## ARCHITECTURAL REVIEW BOARD WORK SESSION AGENDA

**Agenda Item:** APPLICATION FOR ALTERATION TO AN EXISTING STRUCTURE, ARB #26-003, 500 Carlisle Drive, Herndon, Virginia, to consider an application for the erection of exterior equipment screening walls at the property located at located in the eastern side of Carlisle Drive, south of the intersection with Elden Street

This staff memo relates to the proposed Special Exception (SE#25-02) at the property at 250 Spring Street, located north of Spring Street between its intersections with Springpark Place and Herndon Parkway. The site is approximately 4.17 acres in area and features an 87,130 square foot self-storage facility (*Figure 1*). The proposed design expands the self-storage space to a total of 126,775 square feet, with 60,175 square feet of new construction. About 66,600 square feet of the existing self-storage buildings will remain. The site is in the Office and Light Industrial (O&LI) zoning district. This item is continued from the April 1, 2026, ARB work session agenda.

**4 SOUTH ELEVATION**  
SCALE: 1/8" = 1'-0"

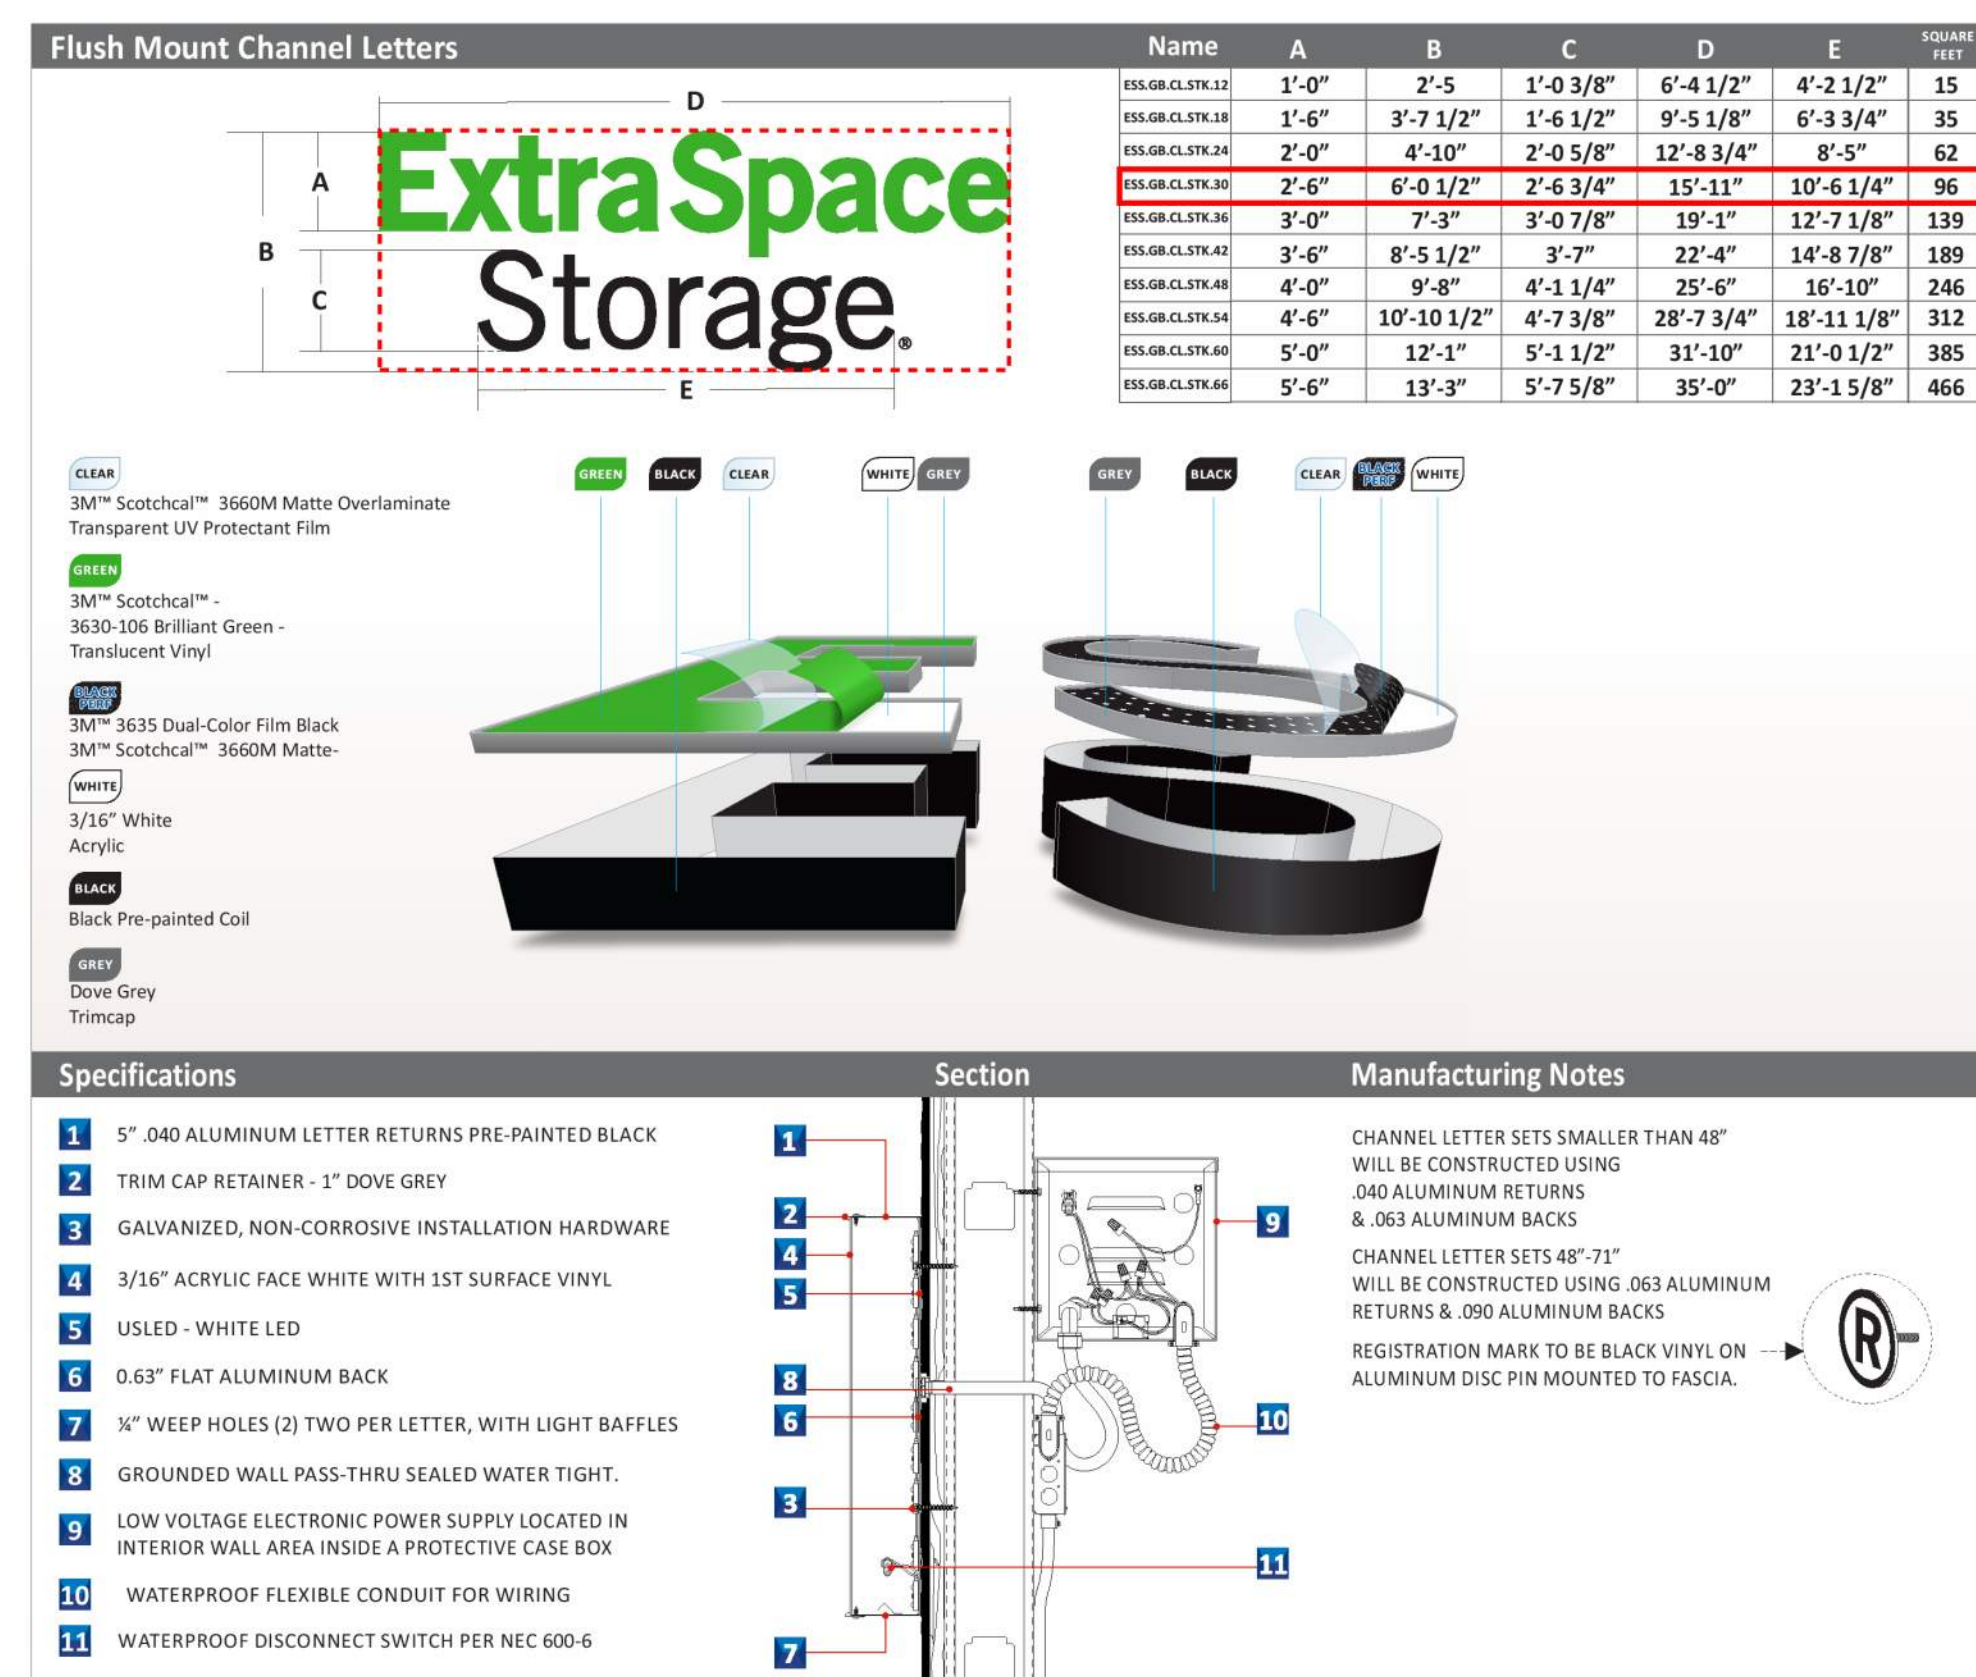
The division of bays on the façade (south elevation) and the west elevation, both highly visible from the right-of-way, establishes a hierarchy between bays and presents a mostly cohesive design. Additional details will be needed to fully understand the articulation of the fenestration on the storefront at the southwest corner, as well as the bay of windows on the façade. Currently, the view of the façade rendered from the southeast corner appears to lack dimensionality in its articulation, but this may be due to the rendering itself rather than the intended design (*Figure 2*). The board should discuss if the notable difference in the overall detailing on the north and east elevations is appropriate given the limited visibility from the right-of-way. Furthermore, the materials provided do not contain information on the size or arrangement of the accompanying self-storage buildings behind the main office. The applicant should provide the board with a plan that shows their arrangement, as well as elevations for a typical building unit's design.

*Architectural Harmony (Criterion 4):* As discussed above, the two most public facing elevations (south and west) are extensively clad in masonry and the articulation and hierarchy of the massing along each elevation is highly resolved. In contrast, the east and north elevations feature large expanses of metal siding and do not have much articulation or hierarchy to break up the wall plane. These elevations have limited visibility from the right-of-way. The ARB should discuss whether this conforms to Criterion 4, which looks to ensure that the treatments for exterior walls of freestanding buildings are harmonious.

*Conformance to Accepted Architectural Principles (Criterion 5):* The proposed design is largely consistent with the massing and overall façade articulation and hierarchy of other ExtraSpace Storage designs that employ brick on the façade (*Figure 5*). However, the articulation of the fenestration appears to be better resolved in the finished examples from elsewhere than it is depicted in the renderings for the proposed design at 250 Spring Street, particularly as seen on the façade (south elevation). The ARB should discuss expectations for appropriate detailing and overall articulation for the fenestration of the proposed design.

*Architectural and Aesthetic Acceptability (Criterion 6):* ACD Criterion 6 is partly concerned with whether or not a proposed design for a commercial building could be construed as an advertisement or a commercial display. The design as proposed refrains from using a color palette that is associated with the brand identity of ExtraSpace Storage, although gray is included in some of the masonry and metal siding detailing and the green of the interior will be partially visible from outside the building. Staff is of the opinion that these details are balanced with the prominent use of red brick and off-white siding on all elevations. The previous design proposal for this property submitted as part of the associated Special Exception employed the branded identity of ExtraSpace Storage to a greater extent than the current design (*Figure 6*; sheets A401-A404 of the May 6 meeting materials). The ARB should discuss whether the updated

Additionally, the use of large swaths of unadorned walls, though largely reflective of the building function, should be assessed for appropriateness and whether additional fenestration or decorative treatments should be employed to add visual interest, manage the scale, and more consistently carry through lines and patterns across the various divergent designs bay-to-bay.
